TOWN OF STONEWALL WASTEWATER TREATMENT LAGOON UPGRADE

MWSB #1374

ADDENDUM No.3

ADDENDUM NUMBER: 3
DATE OF ISSUE: August 11, 2017
ISSUED BY: Brian McIntosh, P.Eng.
Telephone: 204.954.6876

TETRA TECH DRAWING No: 1615360100-DWG-C0009
MWSB No: 1374
SHEET No: **C0009**
REV: 1

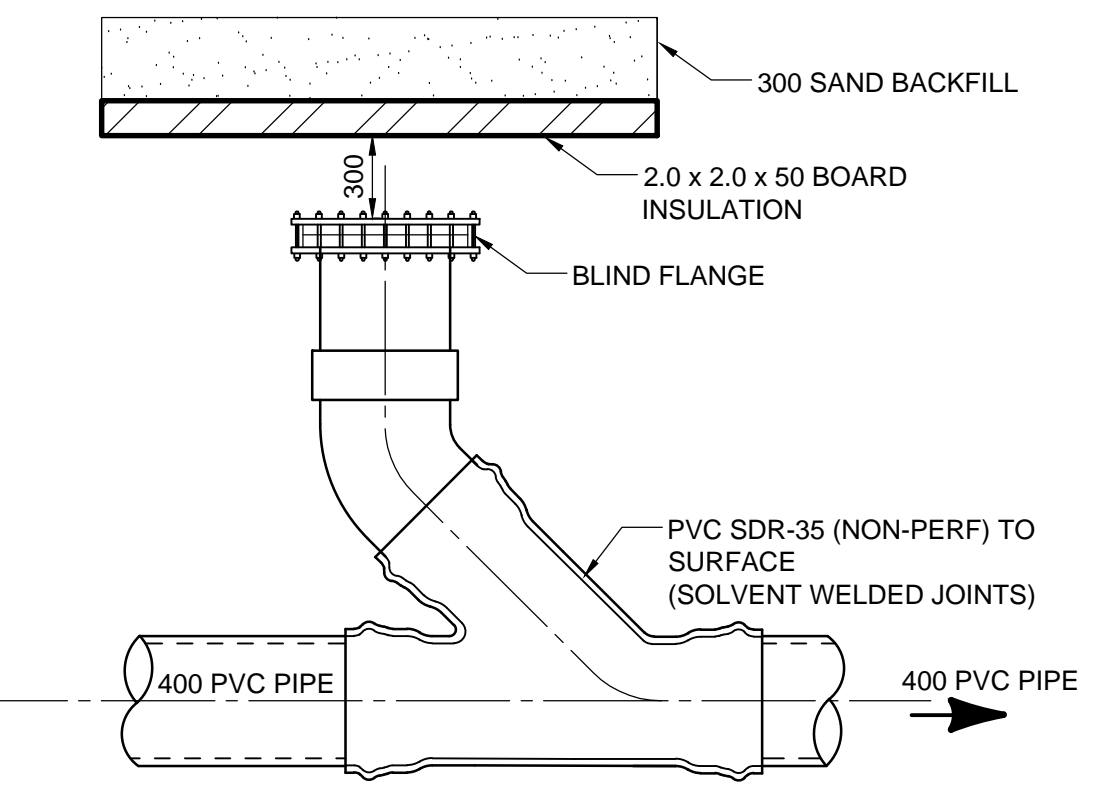
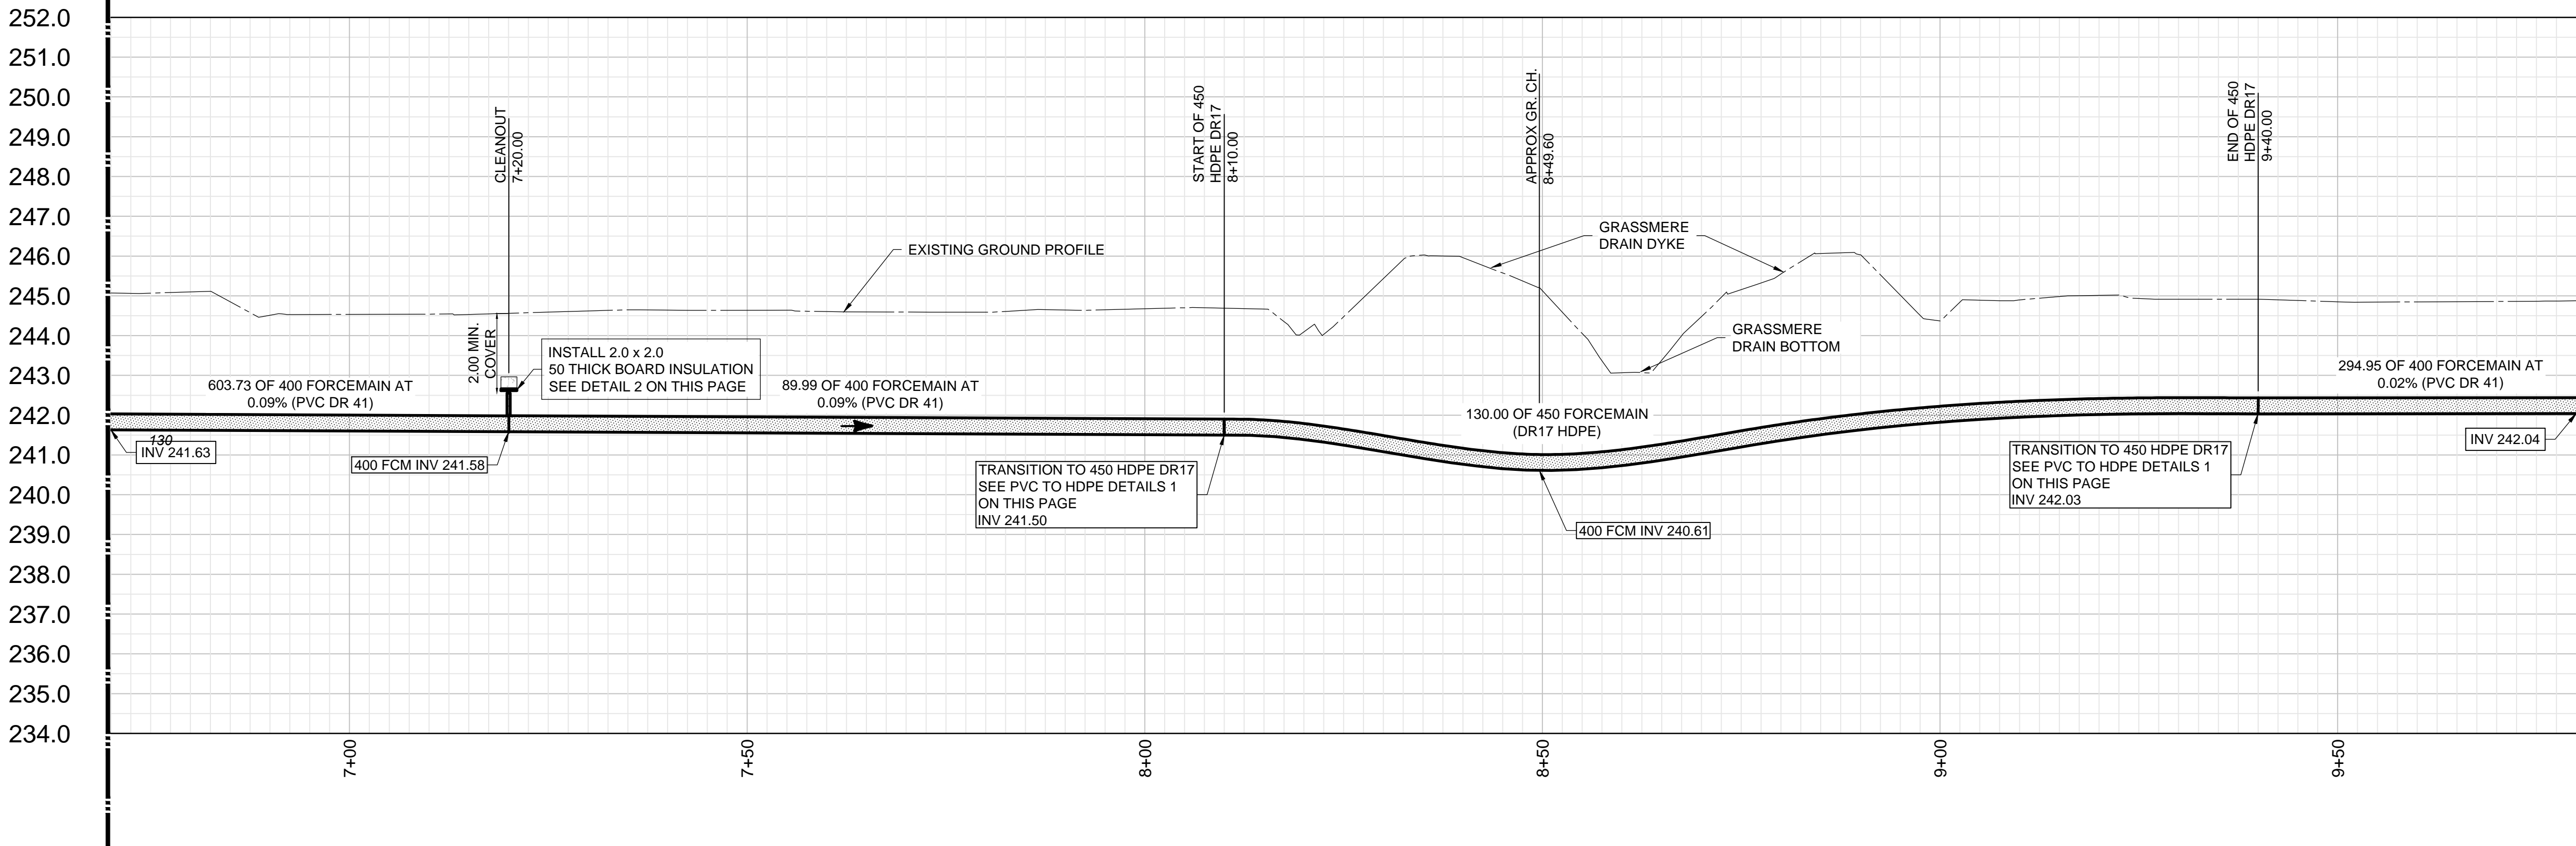
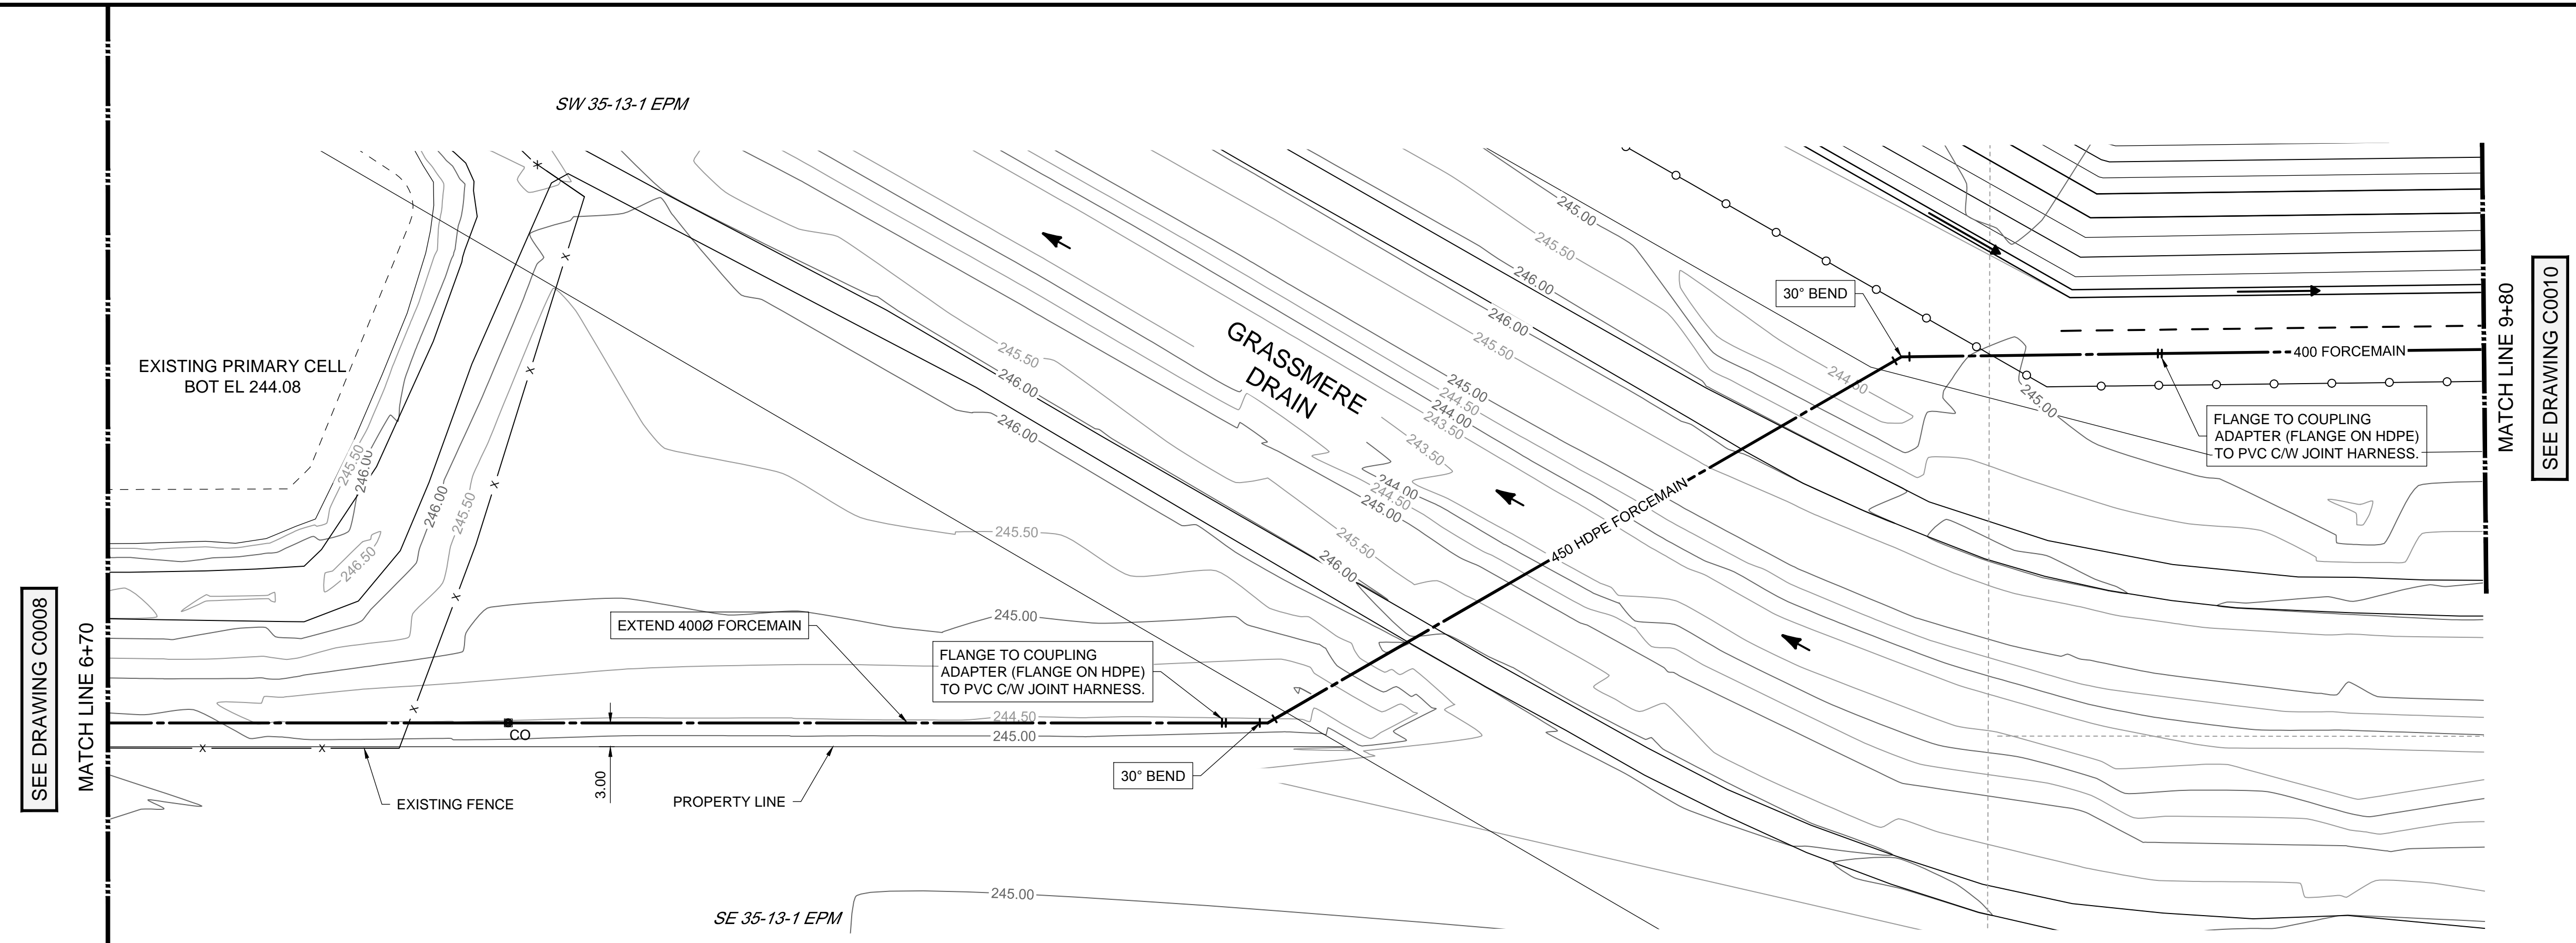
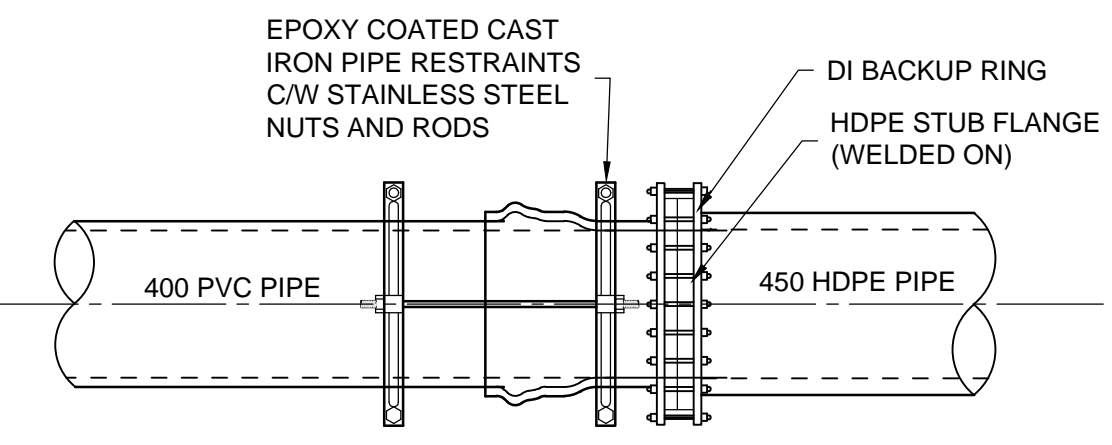
Section 333400R1 - Sewage Forcemain and Drawing C0009 R1 are to replace the existing Section 333400 - Sewage Forcemain and Drawing C0009

130 metres of 400 mm PVC DR41 forcemain crossing the Grassmere Drain will be replaced with 450 mm HDPE DR17 pipe with fittings as per the attached revised Drawing C0009 and revised Section.

1 TRANSITION FROM 400 PVC TO 450 HDPE DR17

2 BURIED CLEANOUT

SHEET No:
C0010

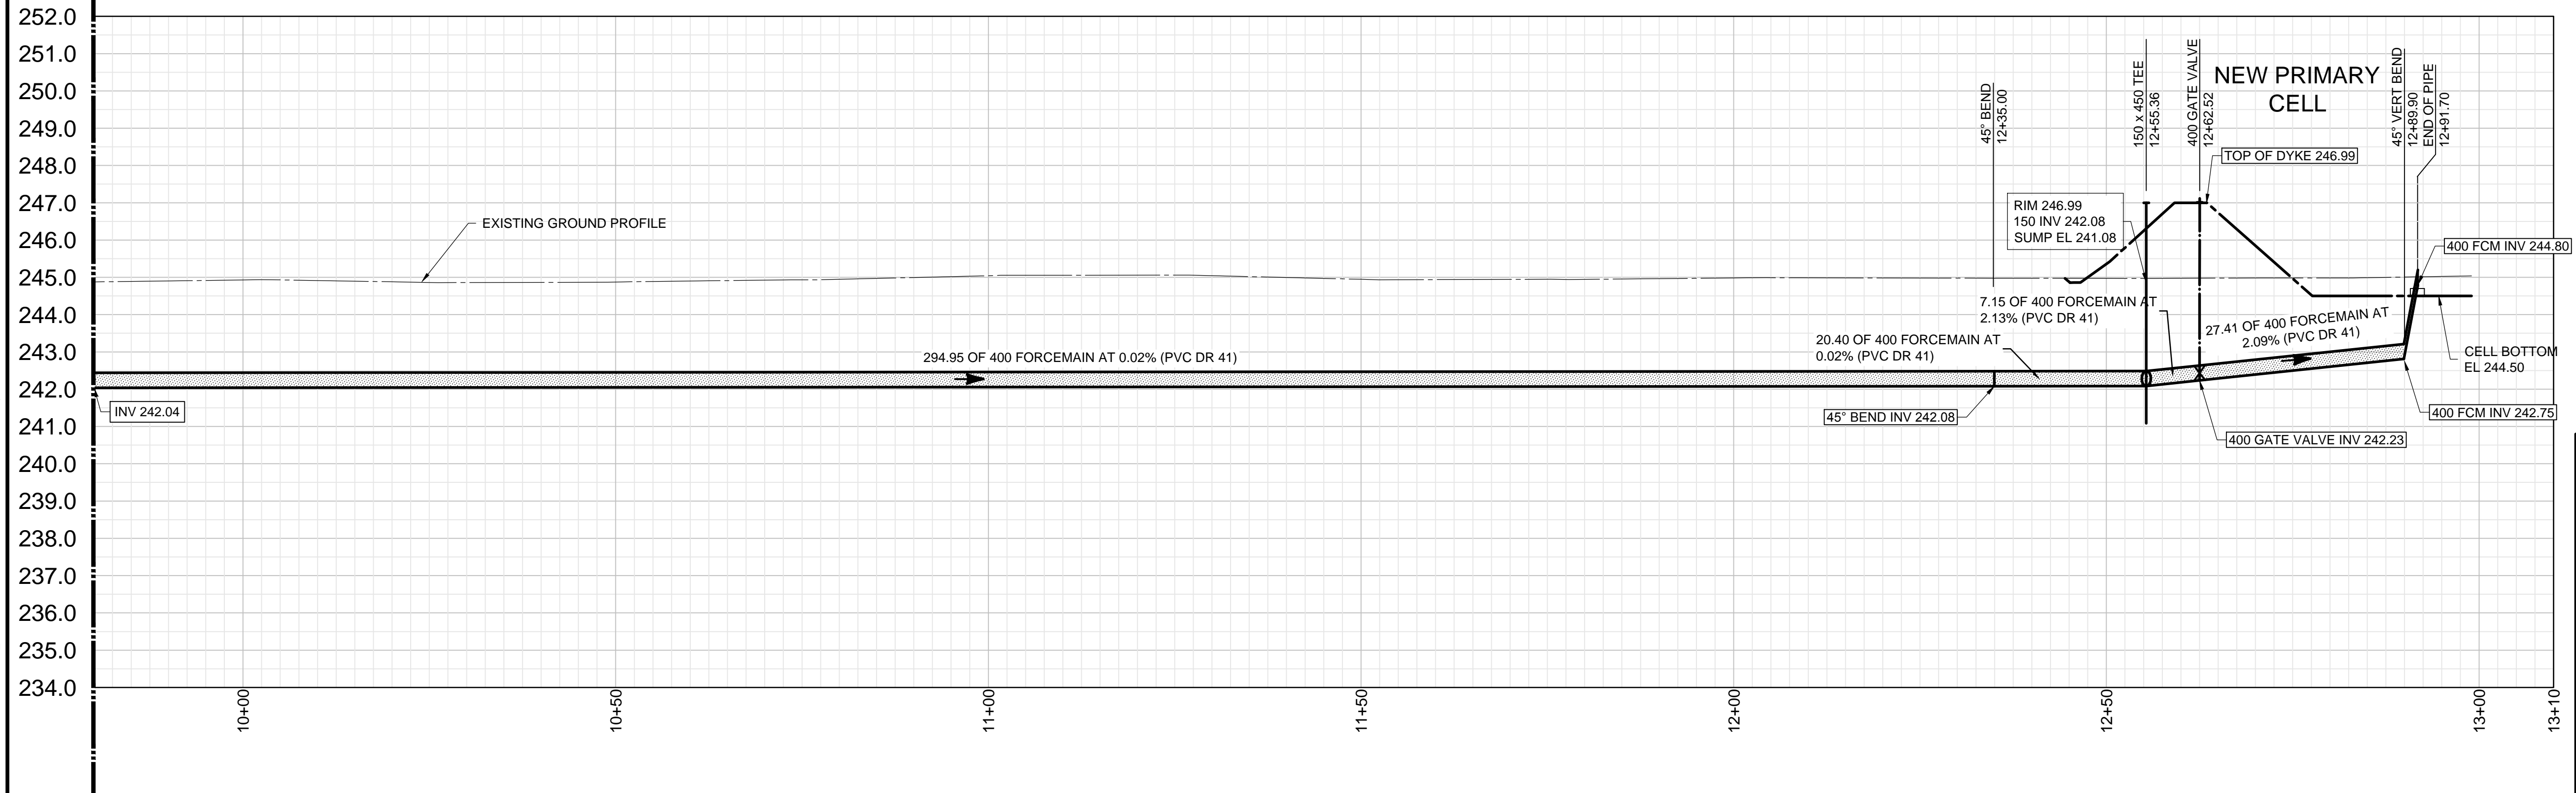
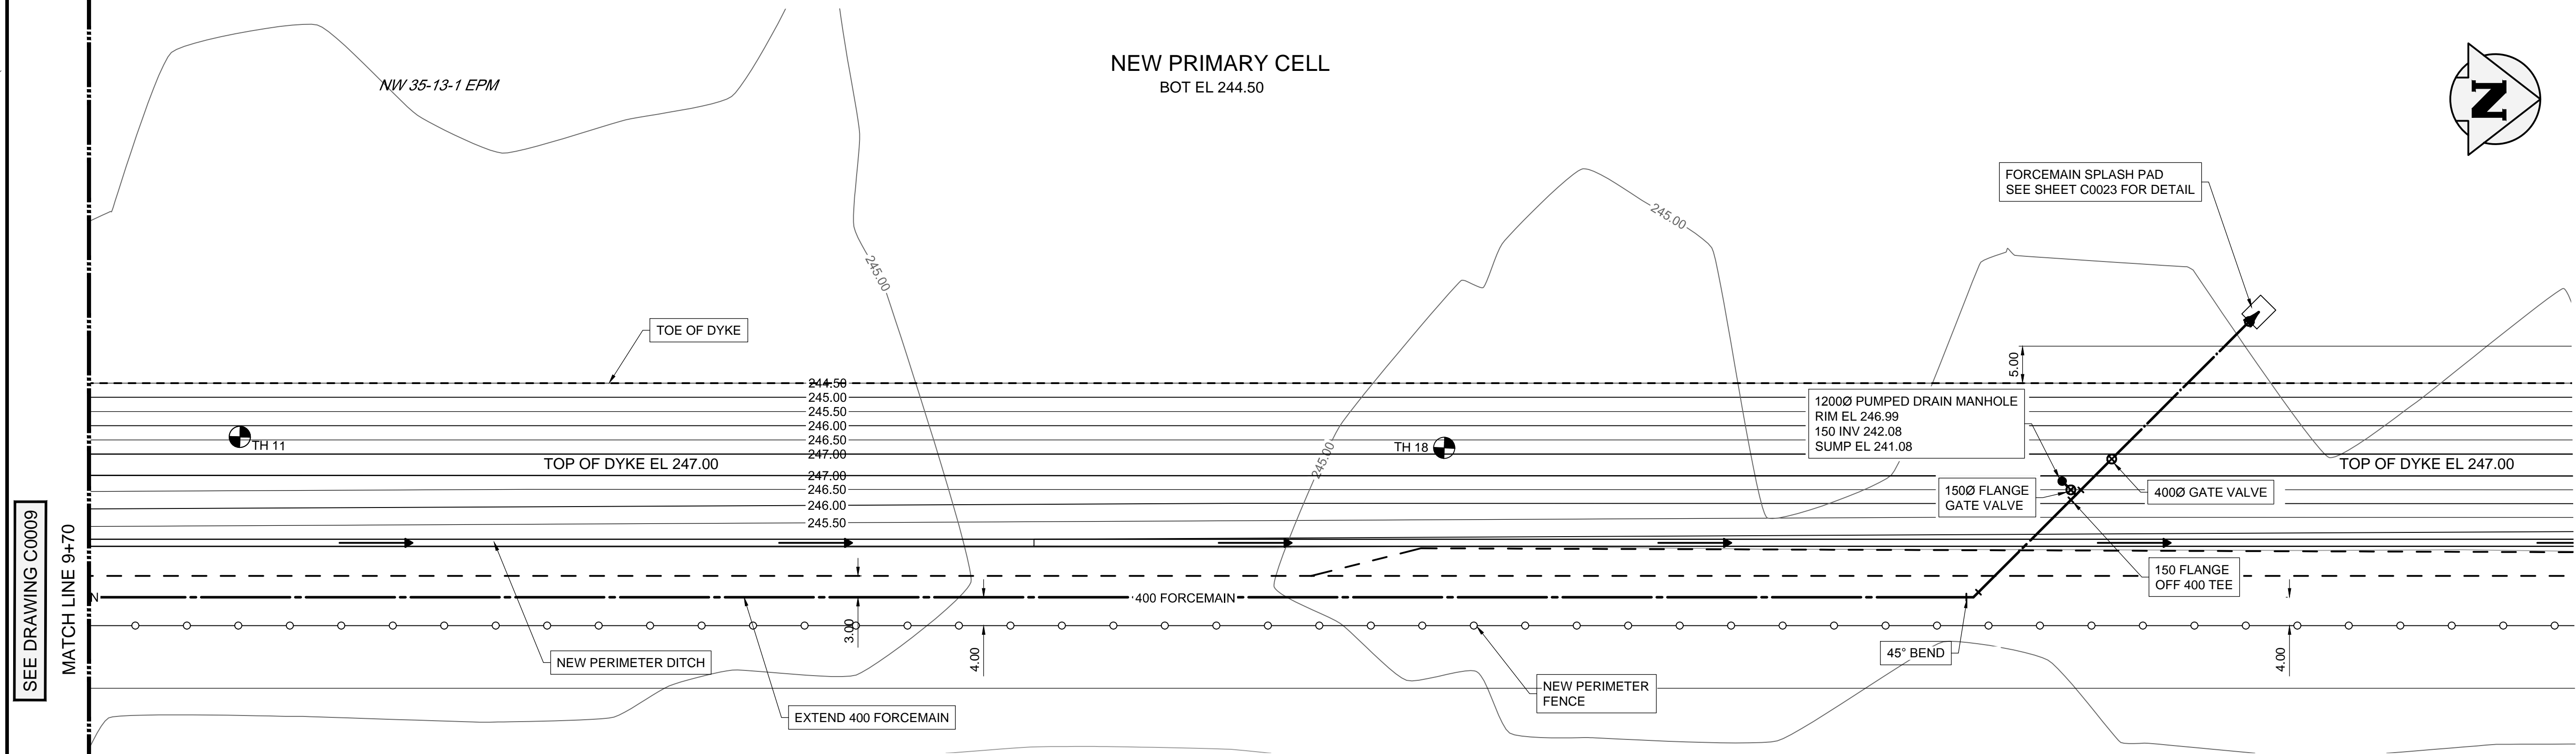
Addition of a new 1200mm MH is shown on Drawing C0010 R1.
